Project name:
NDEP

Technical Memorandum

Subject: RI Modification: Supplemental Surface Water Investigation Plan

AECOM Figure 1

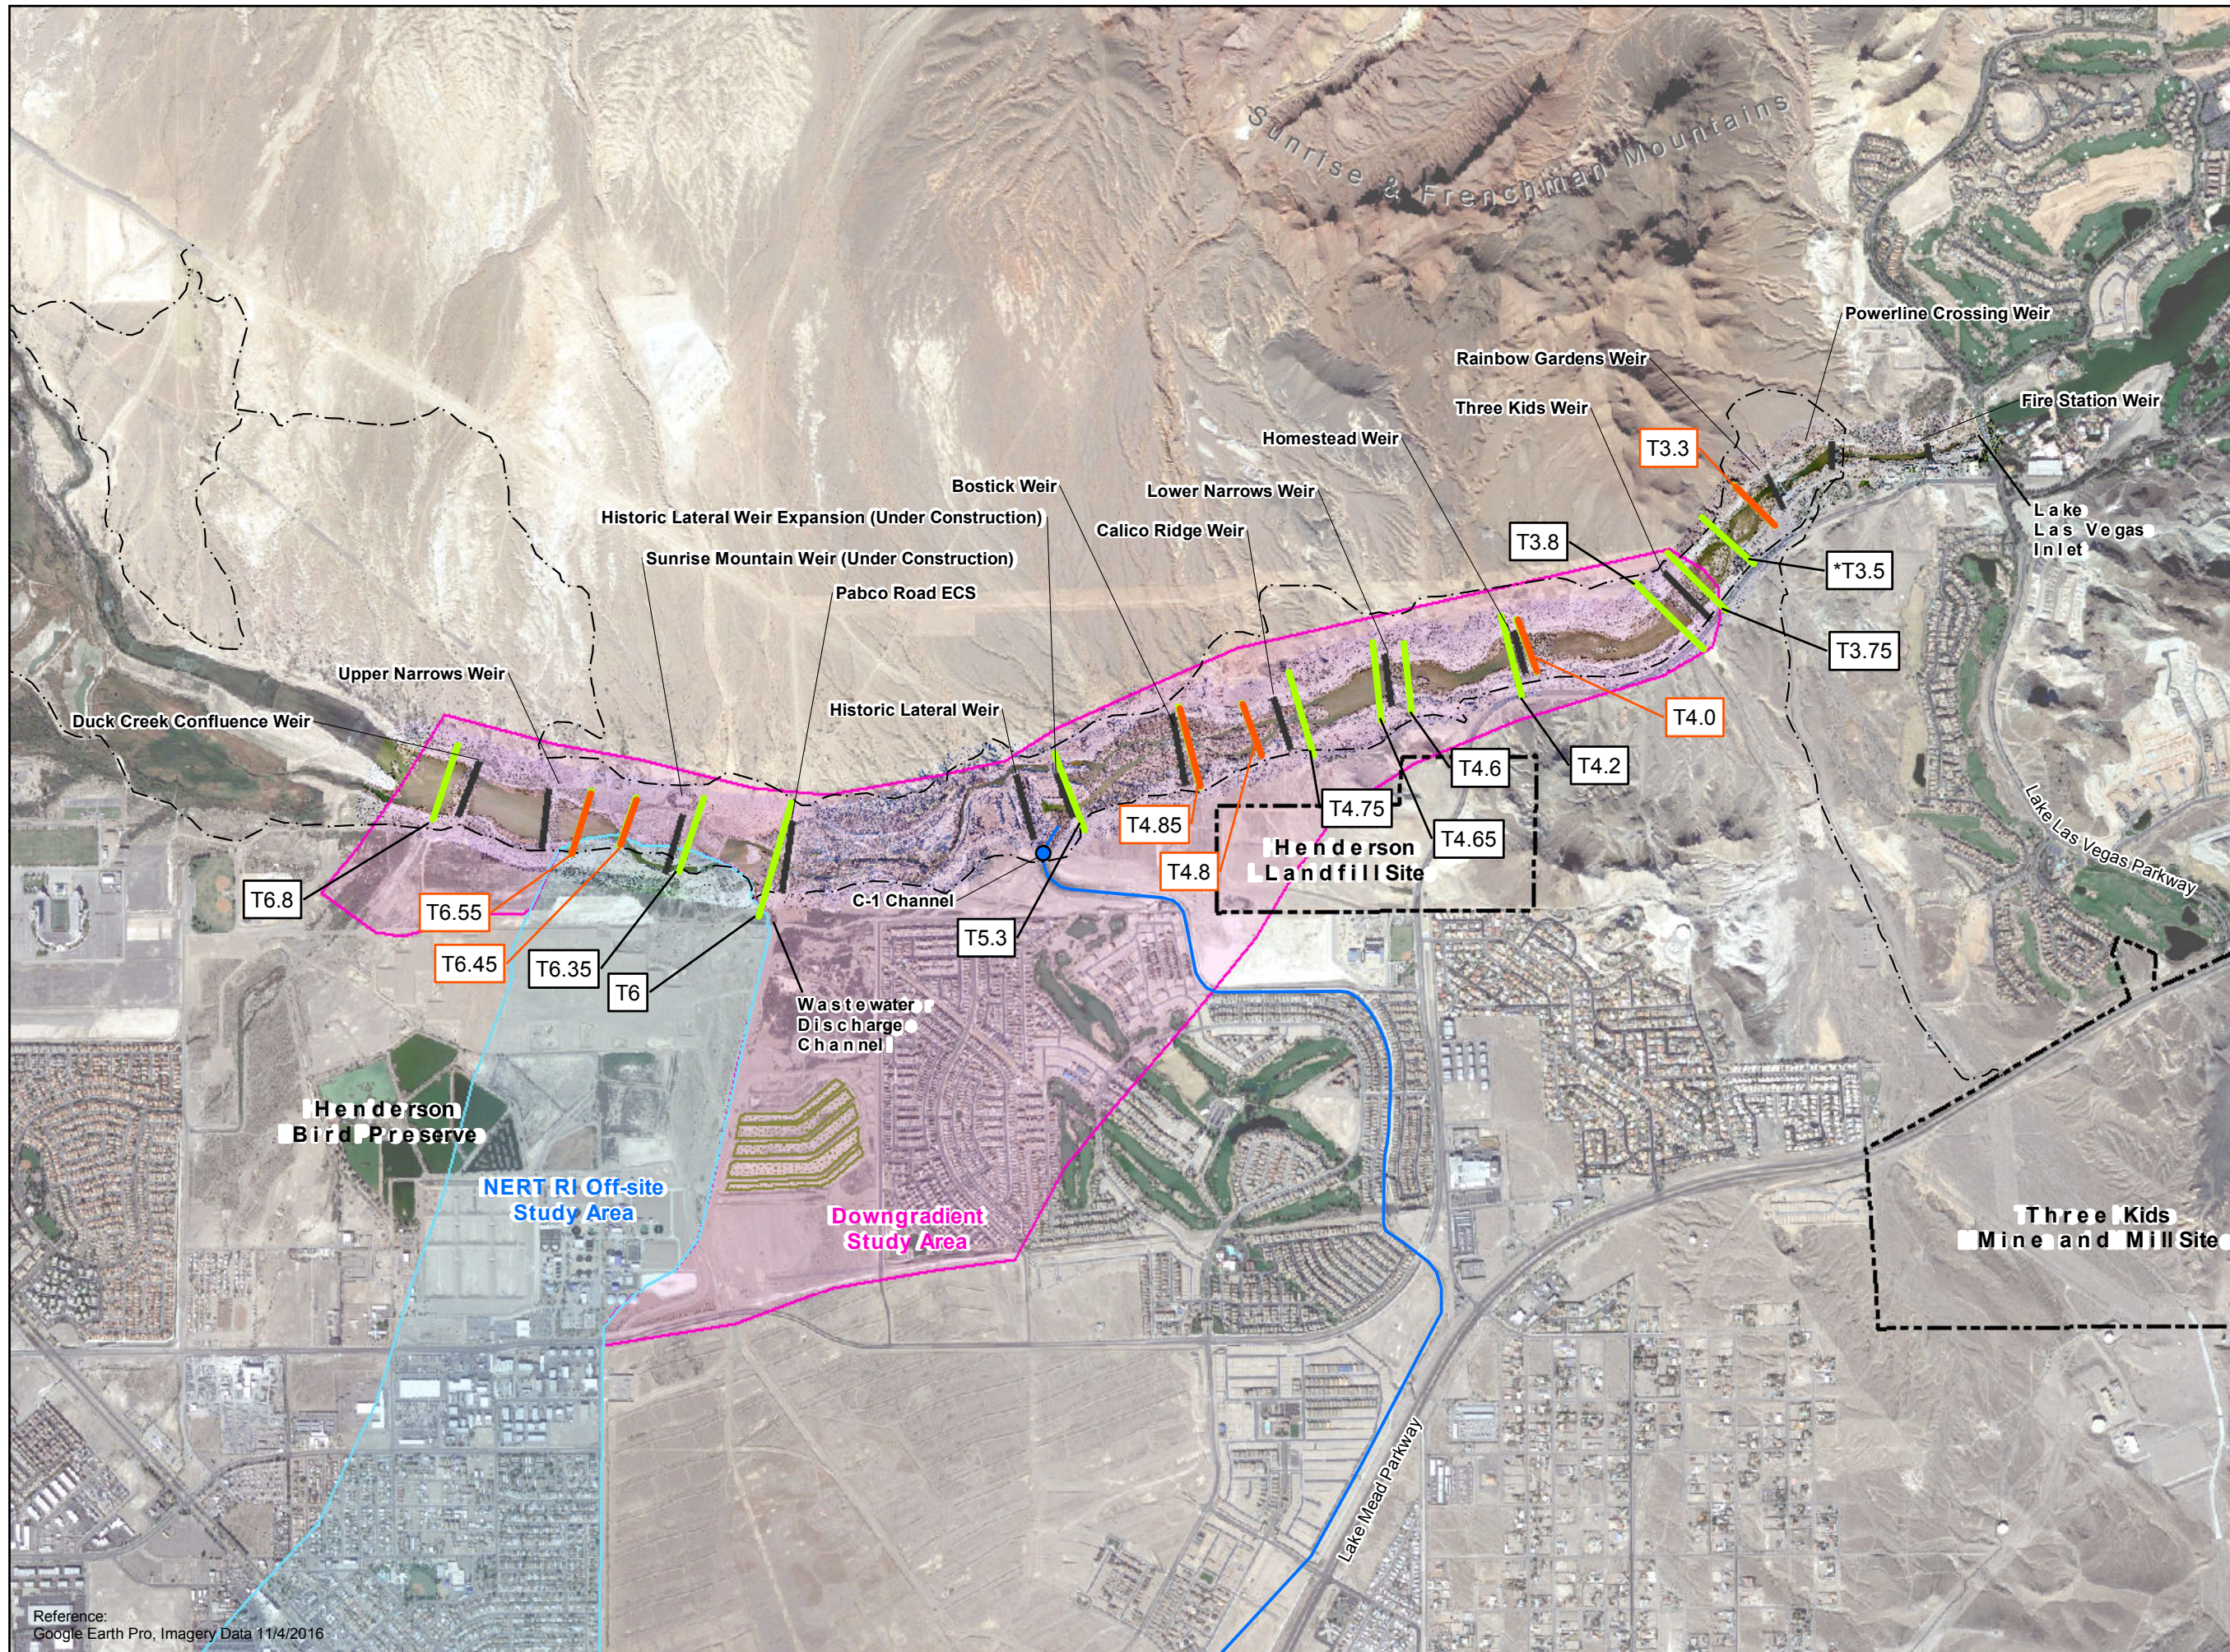
Surface water sampling from 17 transect locations was proposed in the SSWIP. These proposed transect locations are shown on **Figure 1** and the rationale for their initial selection in the SSWIP is described in **Table 1**.

AECOM Figure 2

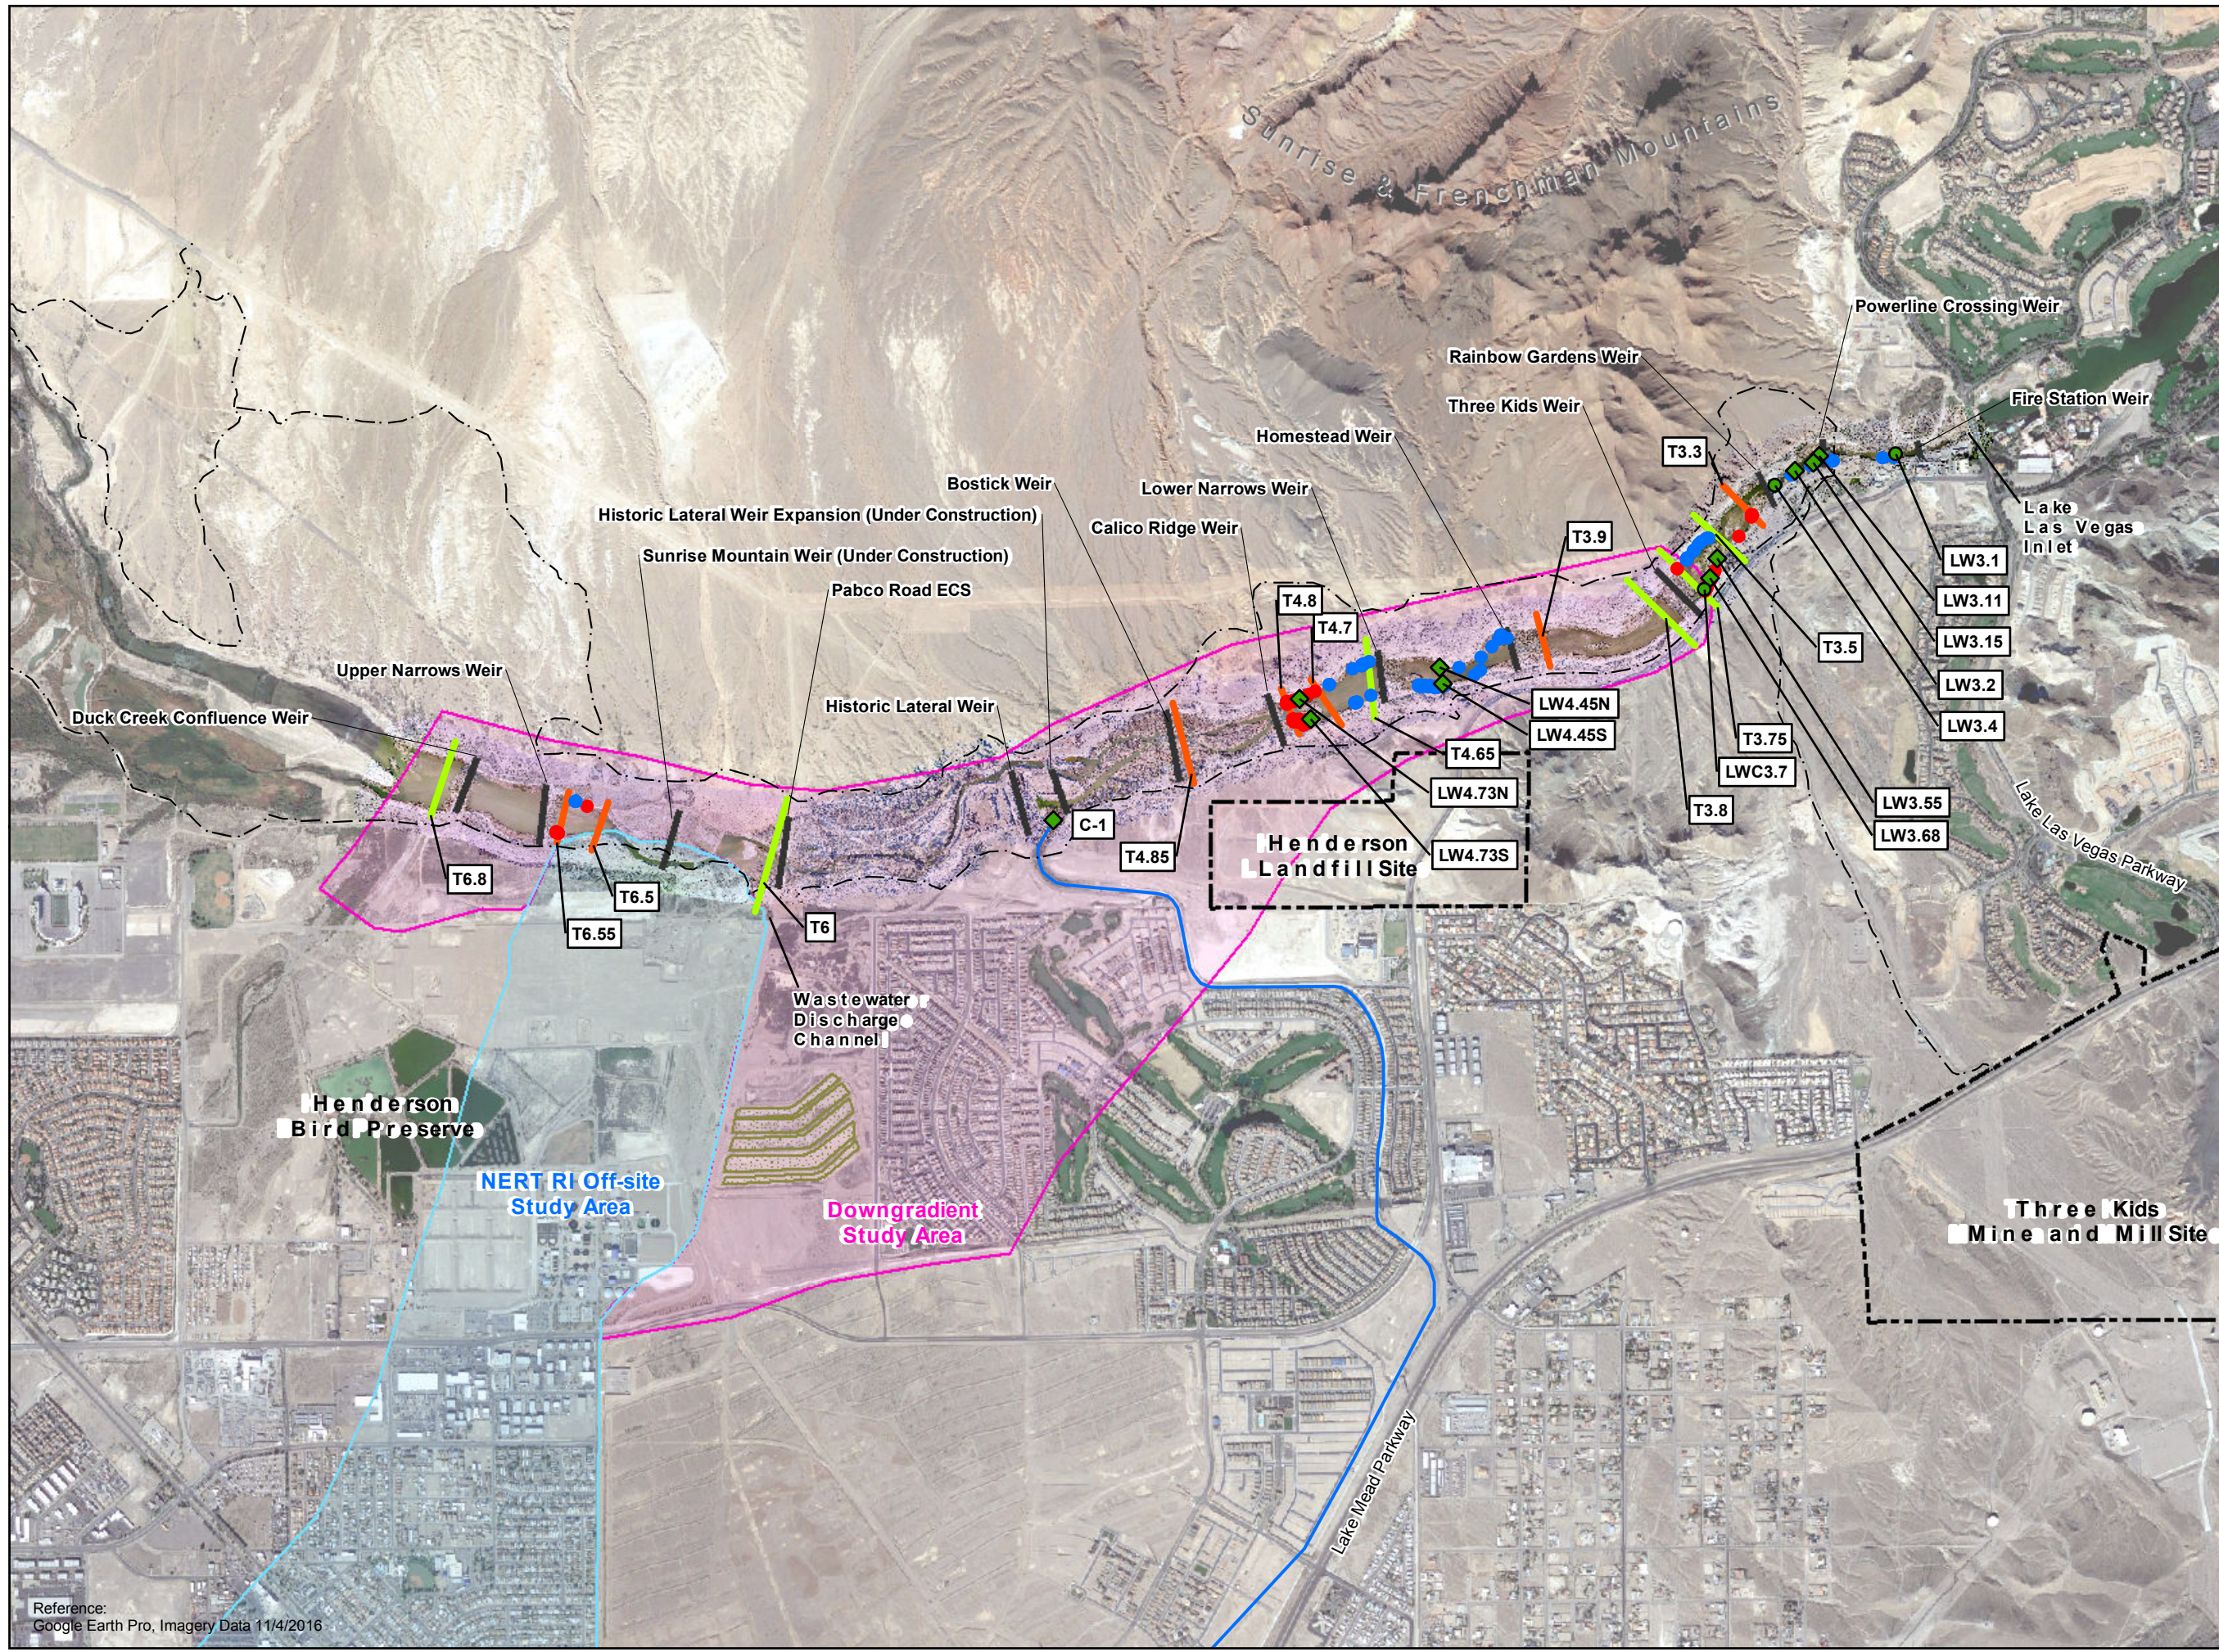
AECOM reviewed the results of the TIR and DTS and suggested modifications of the transect sampling and grab sampling locations to better capture the potential perchlorate inputs. The modified locations were selected based on thermal anomalies (i.e., locations with warmer or cooler water than surrounding surface water) in combination with perchlorate data from previous sampling events. **Figure 2** presents an overview of the proposed modified sample locations (transects and grab samples). A summary of changes to the transect and grab sample locations in the SSWIP is provided below, with references to attached **Tables 2, 3 and 4**, which provide more detailed rationale for removed transects, new sample locations, and unchanged locations, respectively.

- Five transects were removed (**Table 2**):
 - Transect T4.75 was replaced with grab samples near the downstream warm anomalies
 - Transects T4.6 and T4.2 were removed since no changes in perchlorate were noted during previous sampling in this reach and no warm thermal anomalies were encountered during the DTS
 - Two transects were removed due to construction at Sunrise Mountain Weir (T6.35) and Historical Lateral Weir Expansion (T5.3).
- Two transects (T6.45 and T4.0) were moved slightly (**Table 2** and **Table 3**) to T6.5 and T3.9, respectively.

- One transect was added (**Table 3**) at T4.7
- Ten transects were not changed (T6.8, T6.55, T6, T4.85, T4.8, T4.65, T3.8, T3.75, T3.5 and T3.3) (**Table 4**)
